Notice of Electro-Magnetic Switch Change (S-KR11→S-2×T10JH)

Thank you for selecting a Mitsubishi hoist and related products. This letter is to notify the electro-magnetic switch change.

S-KR11 (Before change)	S-2×T10JH (After change)
Appearance		
Overall size (length×side×high)	68.6×82×94.5	75×82×78
Attachment pitch (length×side)	50×73 (2-M4 screw)	60×74 (2-M4 screw)

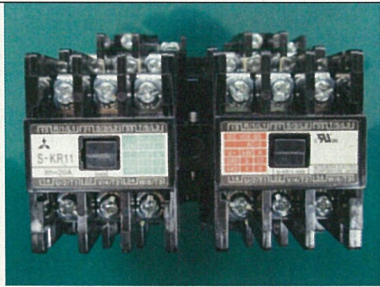
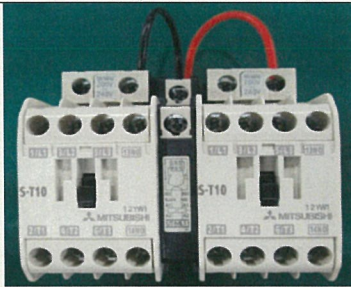
Change Electro-magnetic switch S-KR11 (manufactured by Mitsubishi Electric Corporation) to S-2×T10JH (manufactured by Mitsubishi Electric Corporation).

Part Name of Electro-magnetic switch		Part Code		Compatibility	Overall size and Outward
Existing Product	Switching Products	Existing Product	Switching Products	Incompatible	See below
S-KR11	S-2×T10JH	03G30T	03G32H
